Office of General Services

ADDENDUM NO. 2 TO PROJECT NO. 47676

CONSTRUCTION WORK FUEL TANK MODIFICATION & ENVIRONMENTAL REMEDIATION – WESTERN REGION SERVICE CONTRACT GNARESP CORNING TOWER ALBANY, NY 12242

May 27, 2025

DRAWING NUMBER: C-23

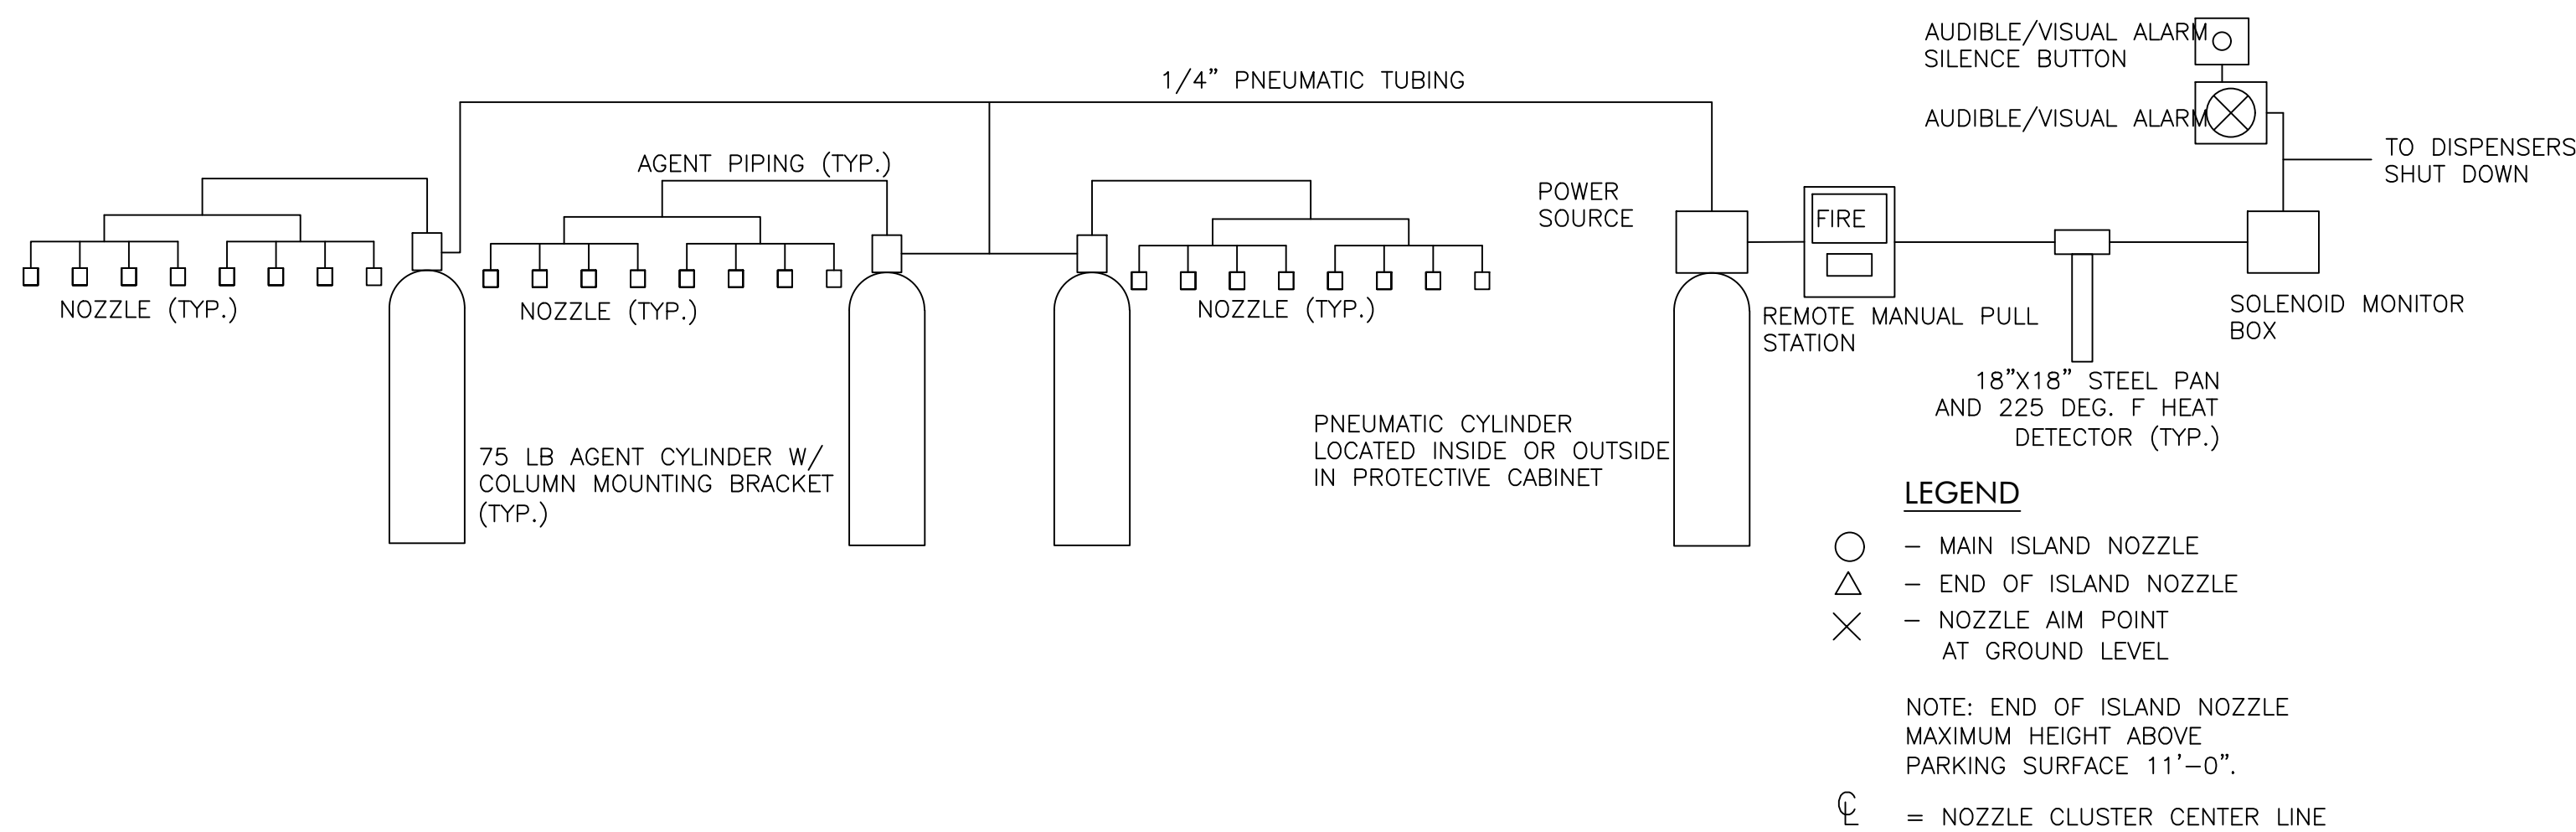
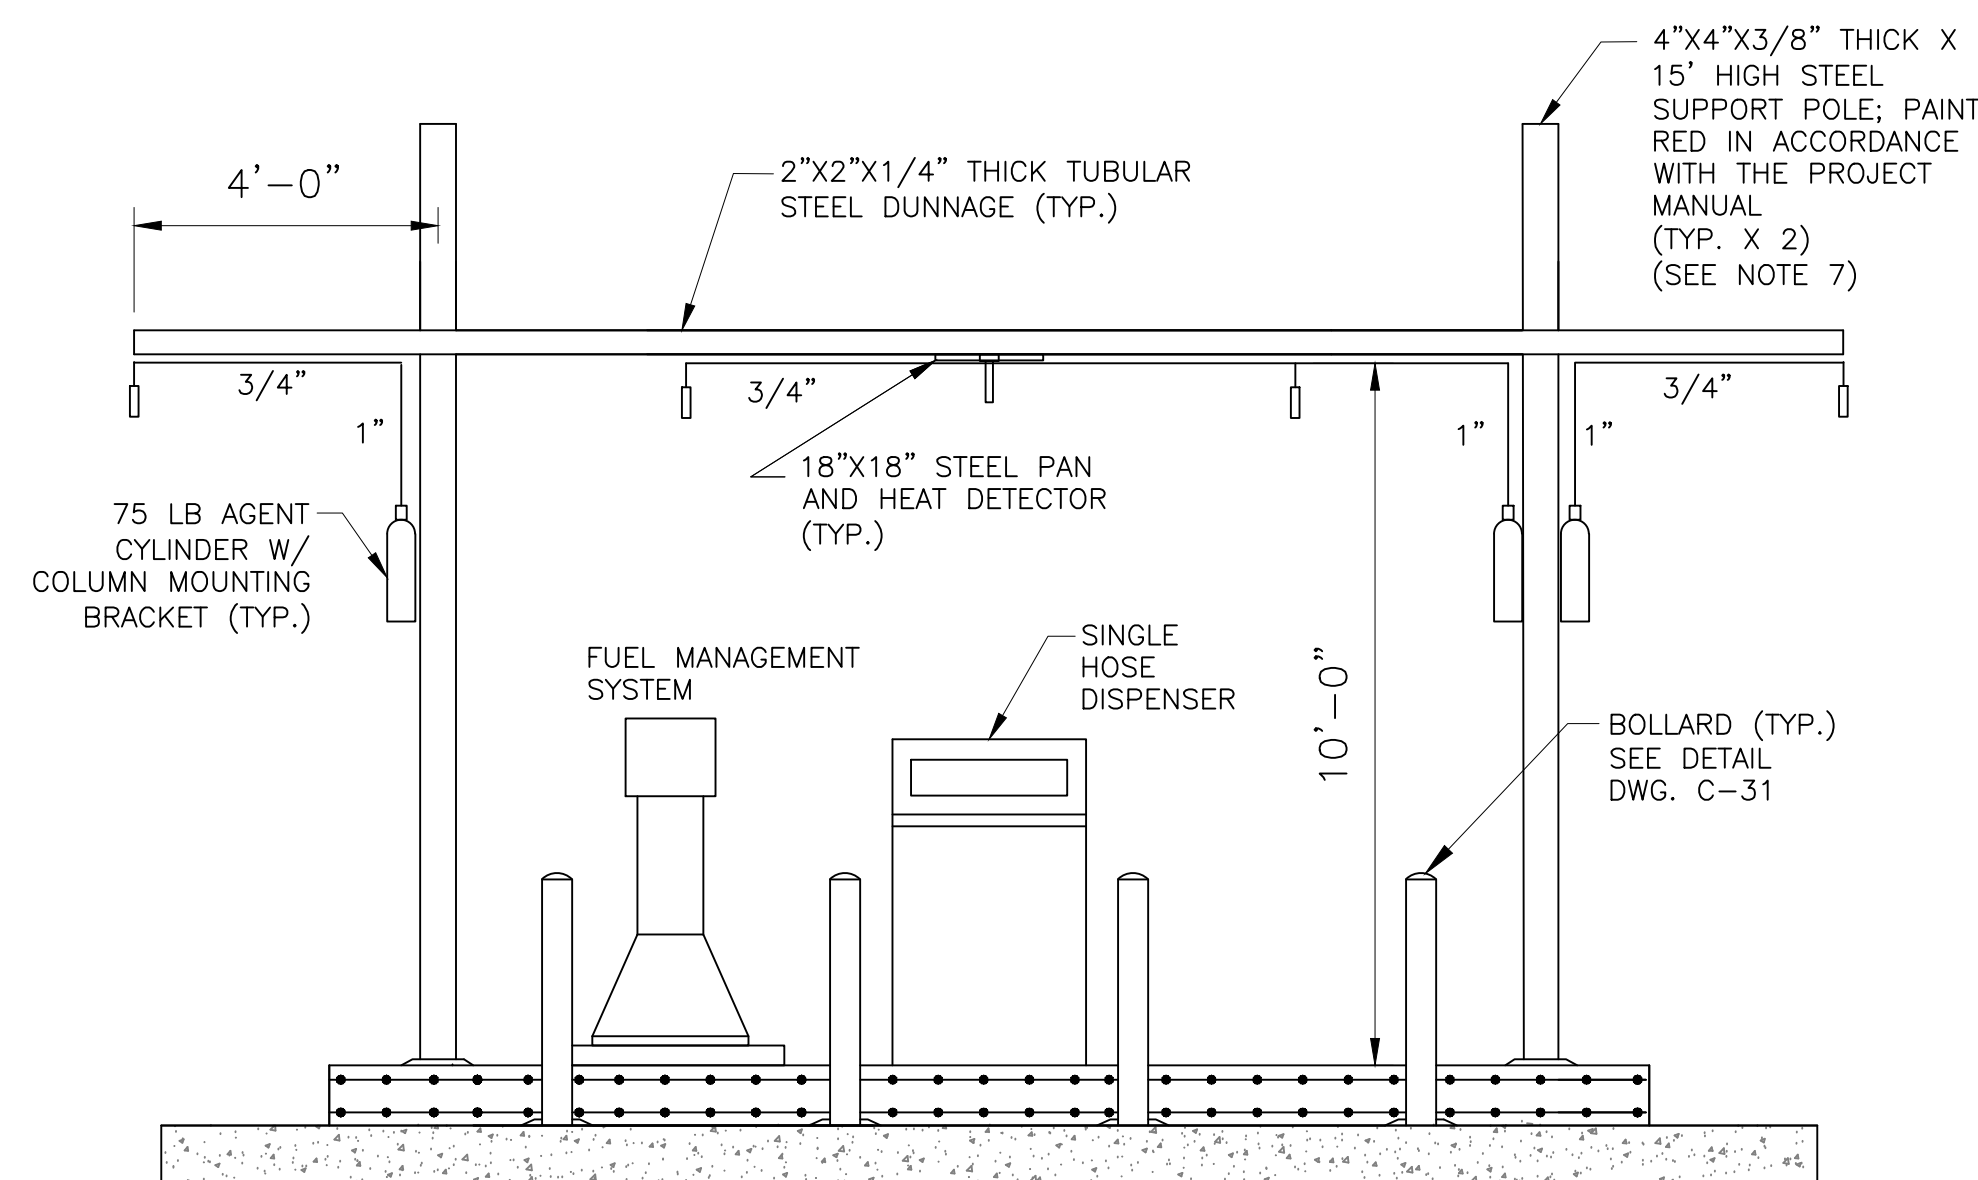
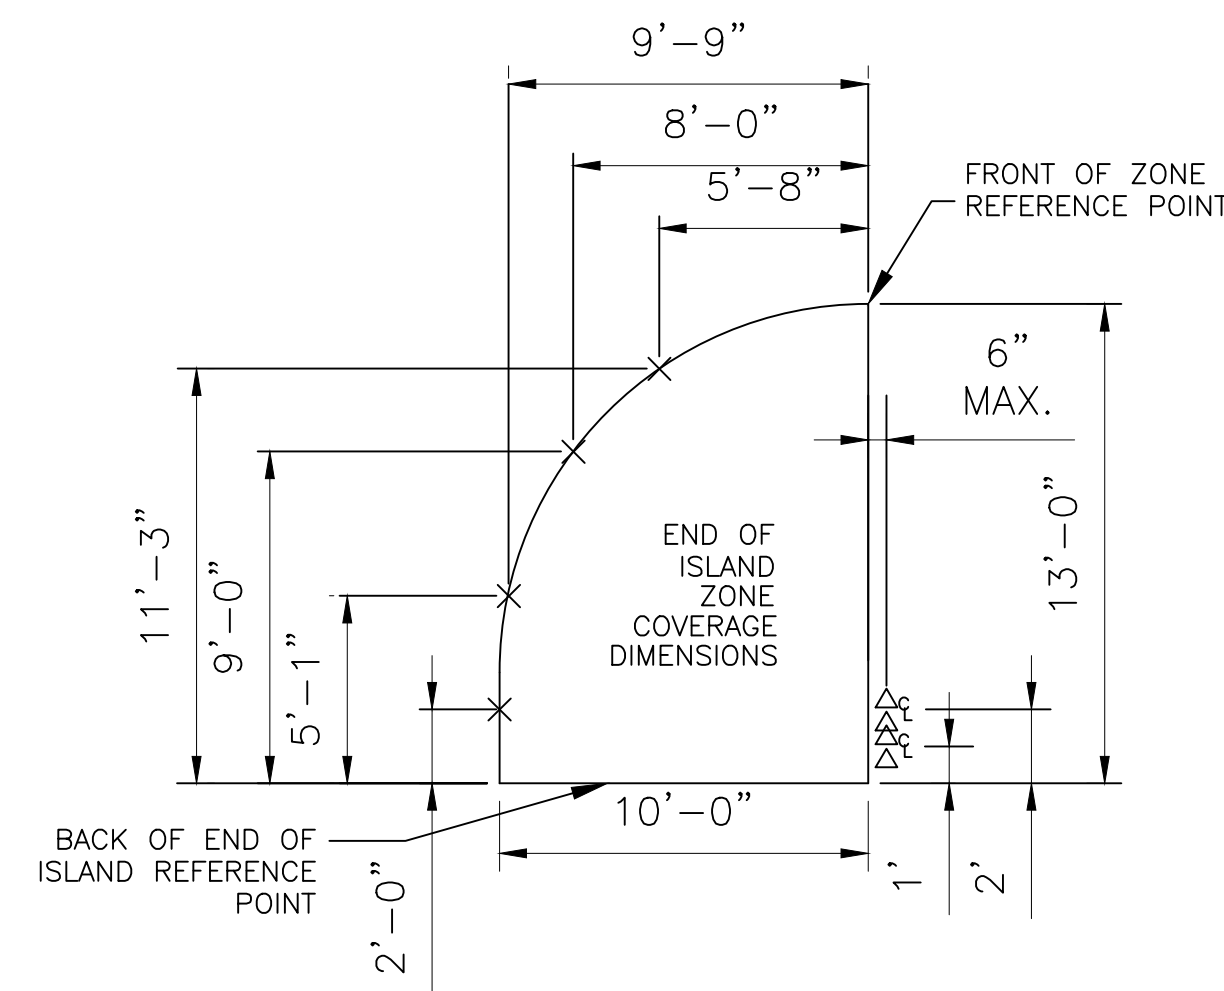
2. Revised Drawings:
 - a. Drawing Nos. C-23, C-24, and C-25, noted “ADDENDUM NO. 2 5/22/2025” accompany this Addendum and supersede the same numbered originally issued drawings.
